PARTS & SERVICE NEWS

REF NO. AA99162

SUBJECT: WORKLAMP RELOCATION

PURPOSE: Relocate worklamps to outside of cab to prevent windshield cracking

Figure 1

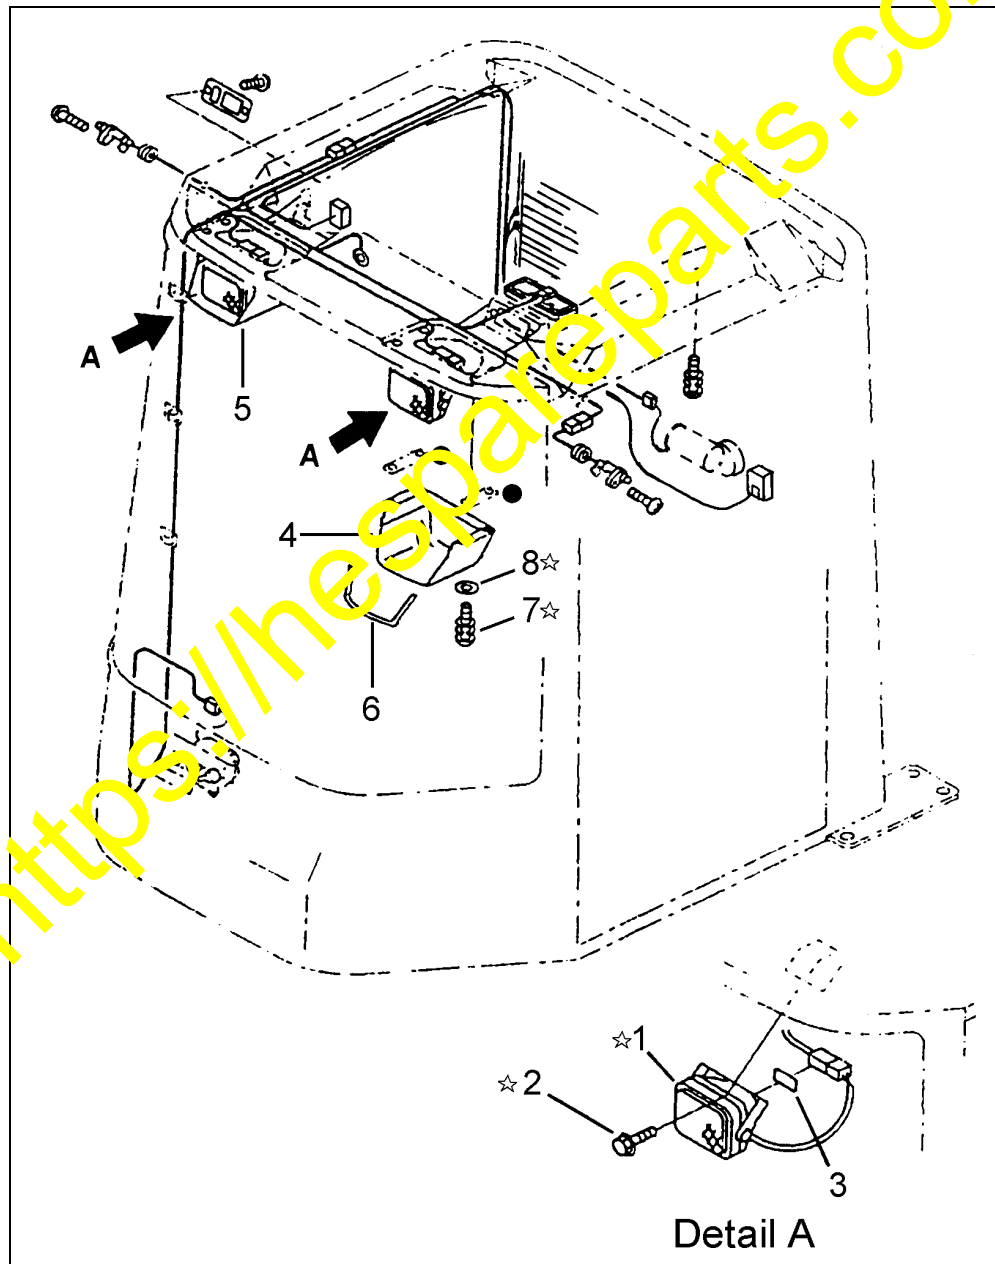
1. Remove screws (7), washers (8), covers (4,5) and seals (6) from worklamps.
2. Disconnect the wiring harness.
3. Remove bolt (2), fastener (3), and lamp assembly (1) from cab.

NOTE: DO NOT discard the star-marked items as these will be reinstalled later. Circle-marked items (left-hand side only) must be reinstalled for the Audiovox radio kit.

Figure 2

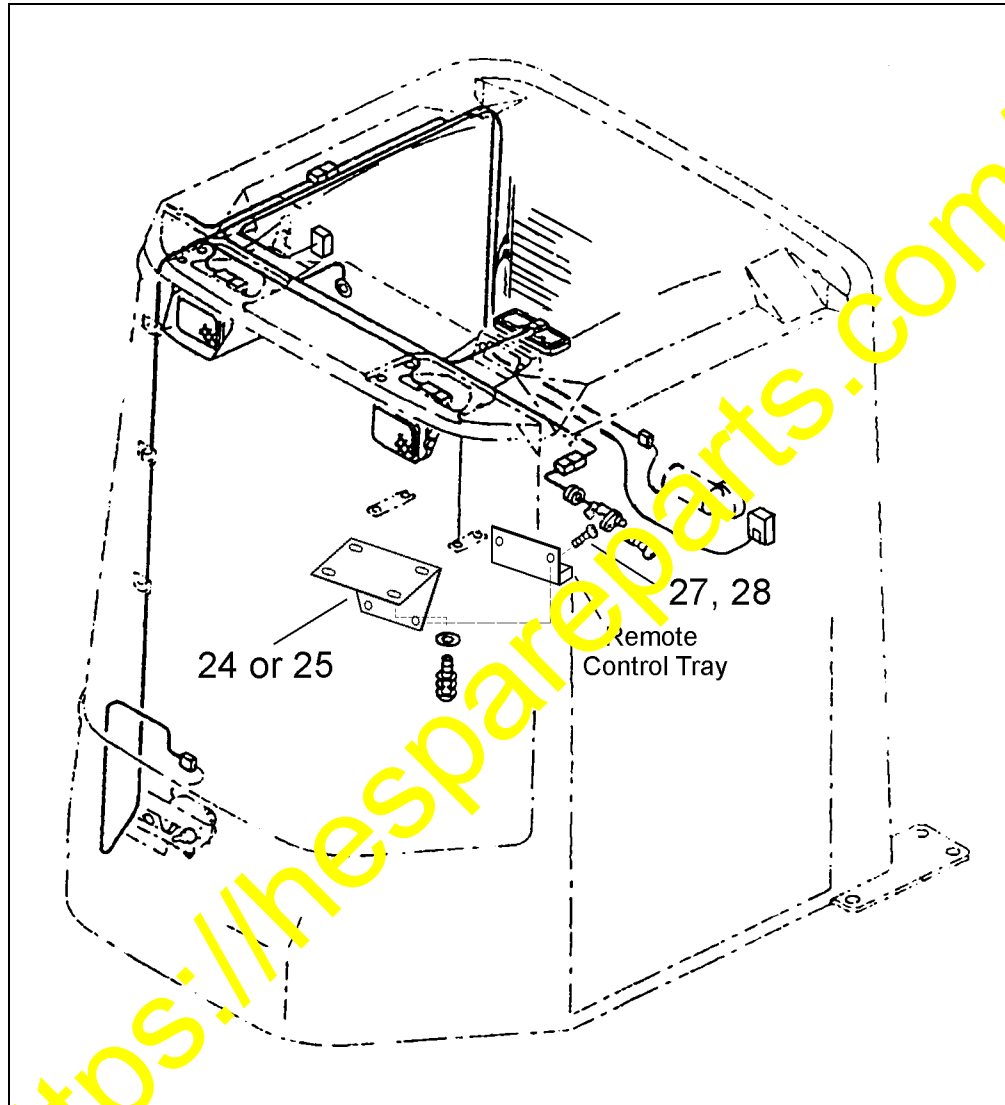
NOTE: This step applies only to machines equipped with an Audiovox radio kit.

4. Mount the proper bracket (24 or 25) depending on windshield type with the existing screws (27) and nuts (28). (See Figure 2).

Figure 3

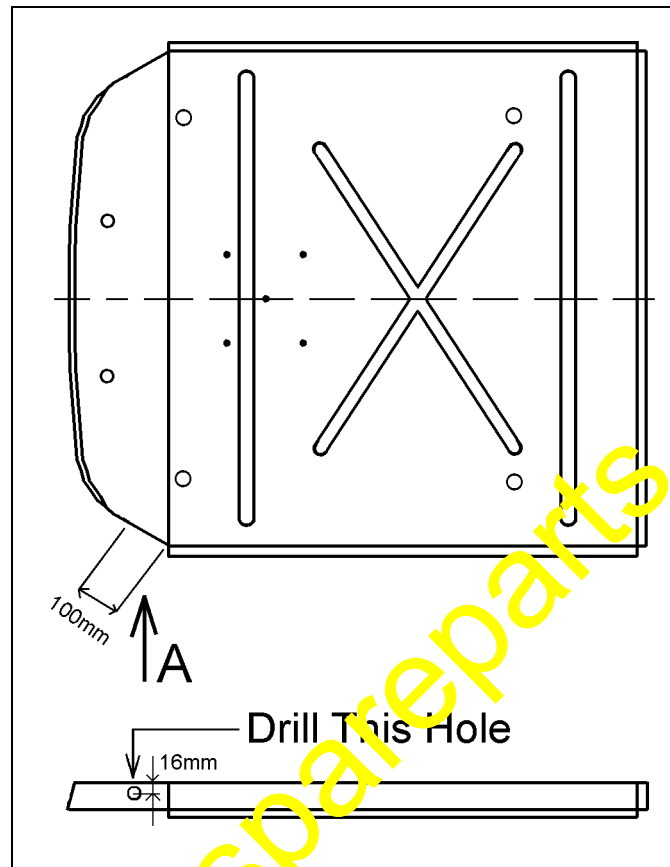
5. Rework the cab roof as shown in Figure 3. One hole, 15mm in diameter, must be drilled on the left and right-hand side of the cab roof.

Figure 4

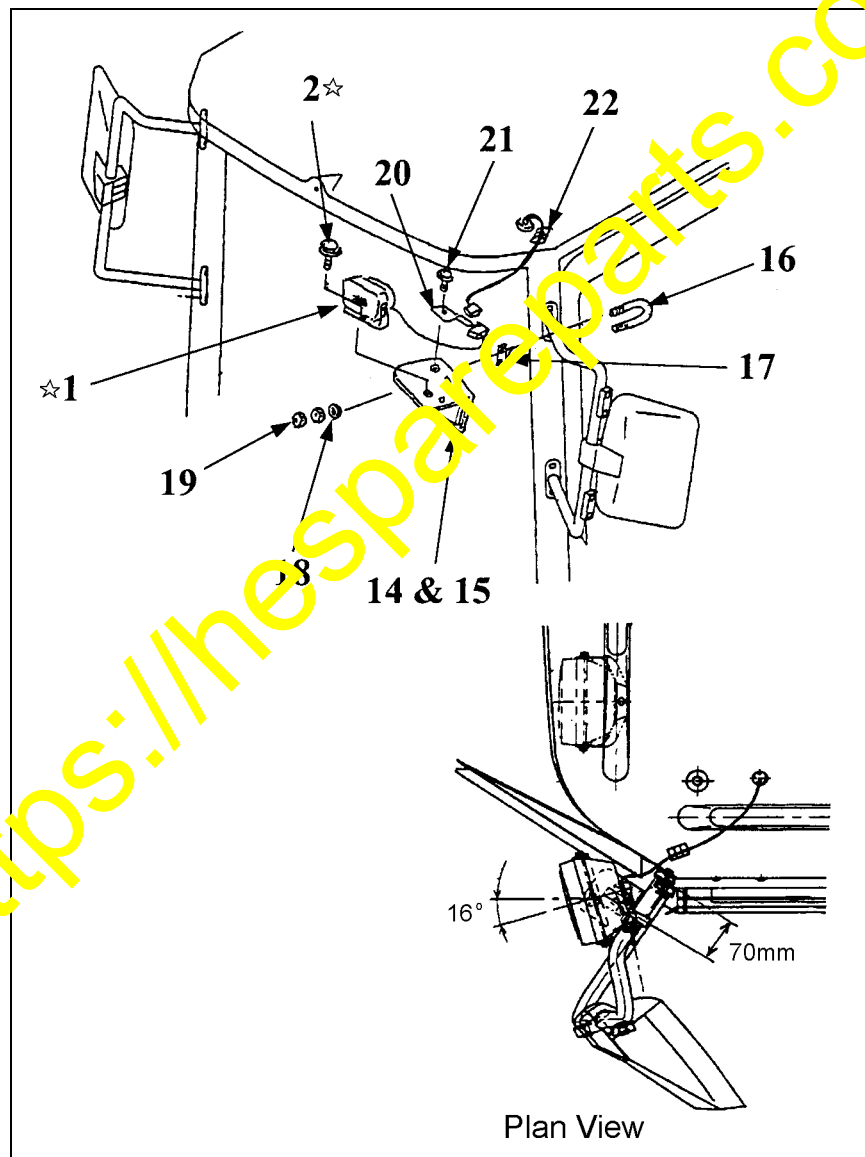
6. Using u-bolt (16) and seat (17), attach brackets (14,15) to the upper arm of the mirror stay with washer (18) and nuts (19).
7. Using bolt (2), install worklamp (1) on bracket and tighten to KES standards.
8. Using bolt (21), install clip (20) on bracket.
9. Connect wiring harness and attach to clip (20).
10. Using clip (22), secure wire harness to cab.
11. As shown in the plan view in Figure 4, adjust the worklamp away from the windshield to prevent interior glare.

NOTE: Figure 4 shows the left-hand side of the cab. Follow the same procedure for the right-hand side.

Figure 5

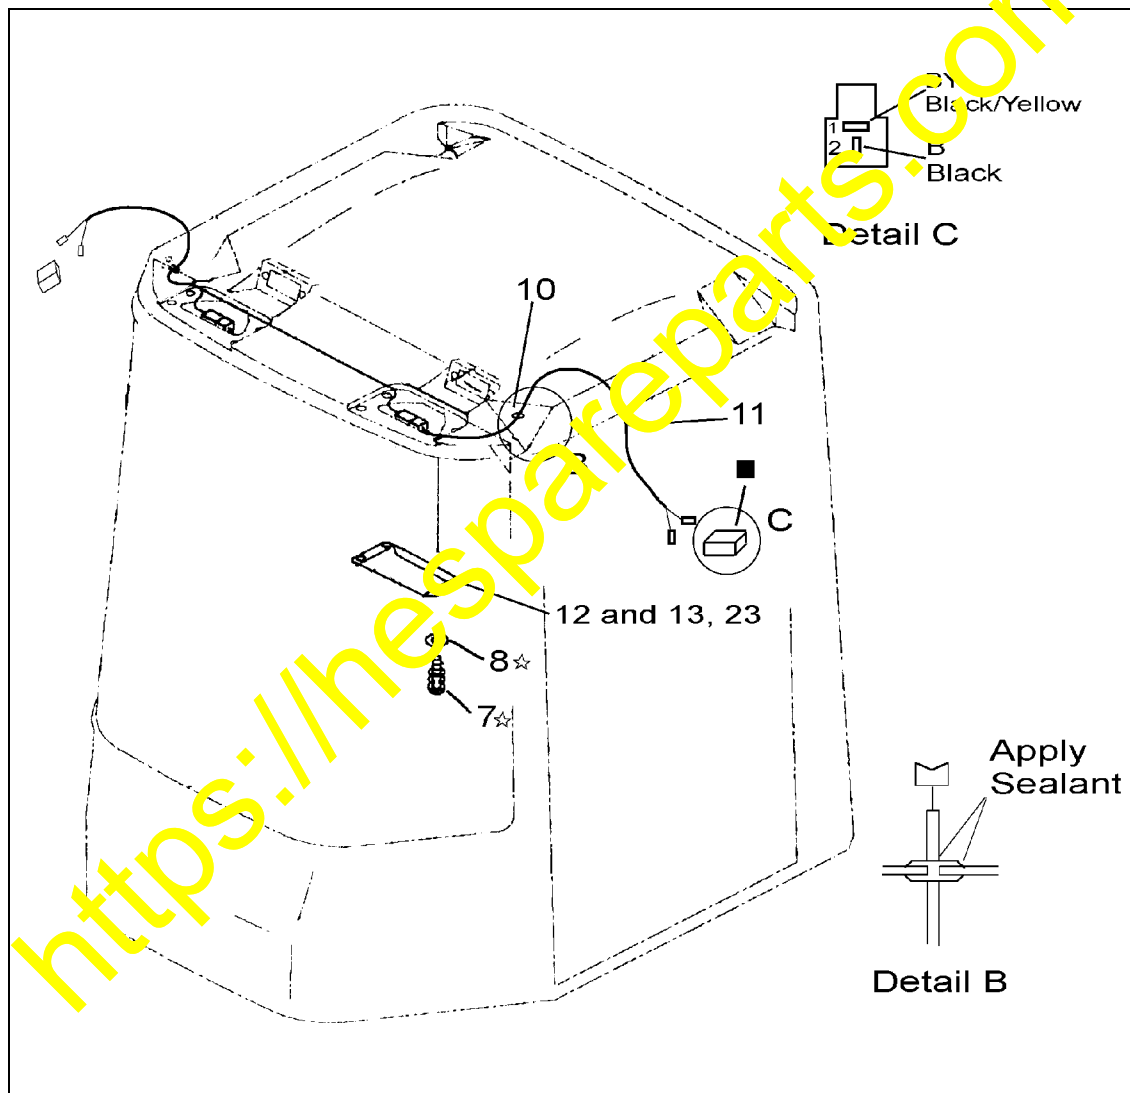
12. Thread the wiring harness through the hole in the cab and connect to existing harness.
13. As shown in Detail B, place grommet (10) over harness and into the hole in the cab. Apply Threebond 5211E or equivalent sealant between grommet and cab and between harness and grommet.
14. Using screws (7) and washers (8), install new plates (12 and 13, or 23).
15. Install the connector (Detail C) on the wiring harness (11).

- NOTES:**
- a. Star-marked parts are those which are being reused.
 - b. The square-marked part is a connector which is shipped loose with the harness (11) and must be installed after the harness has been installed on the cab.

Figure 6

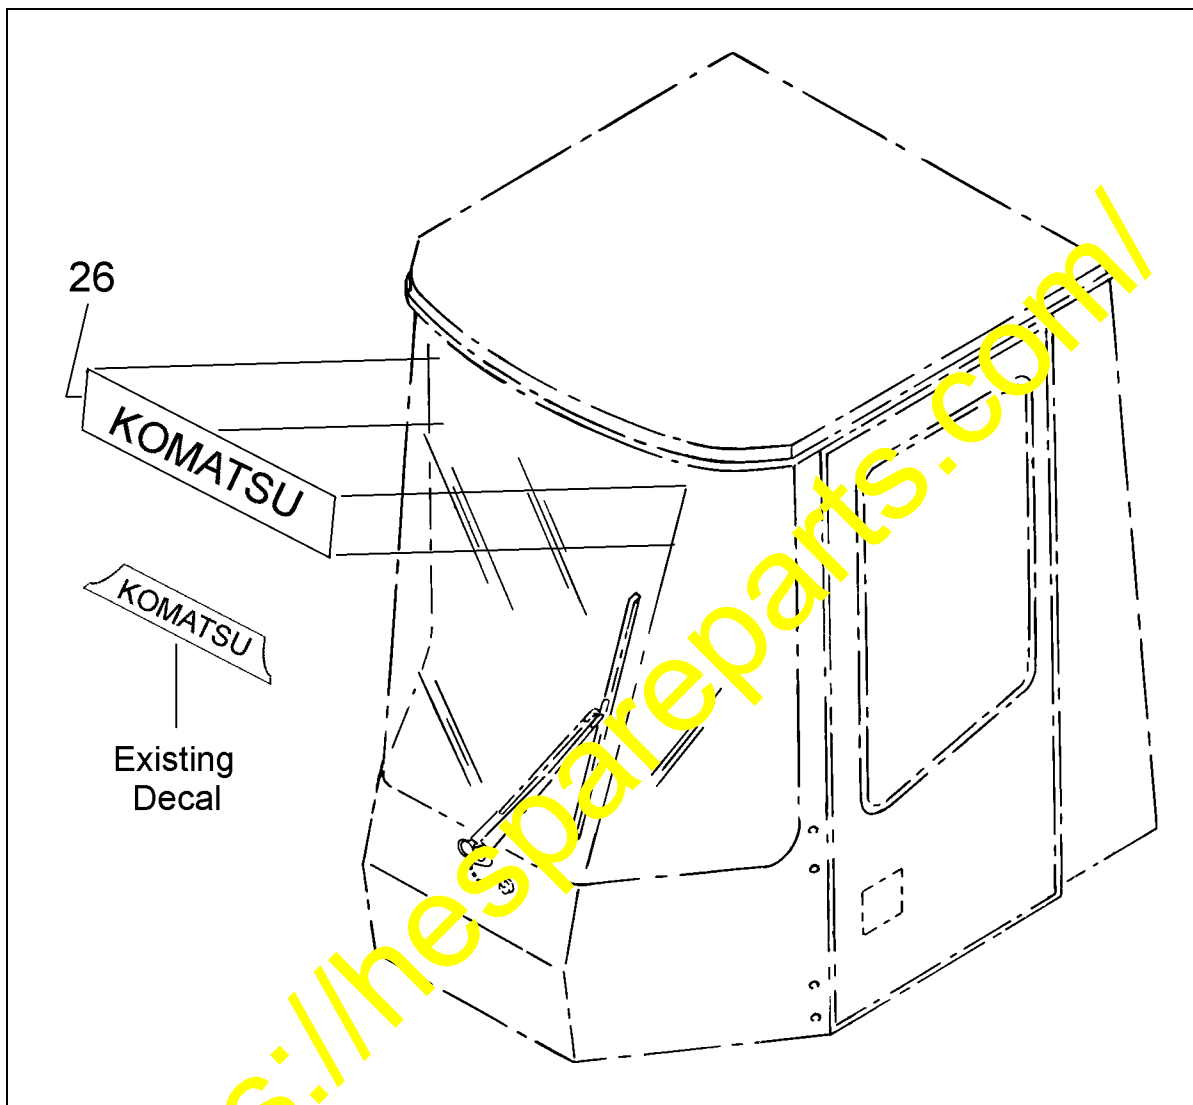
16. For "Avance Plus" models, replace the existing decal with the new decal (26). Figure 6 shows the proper location for the new decal.
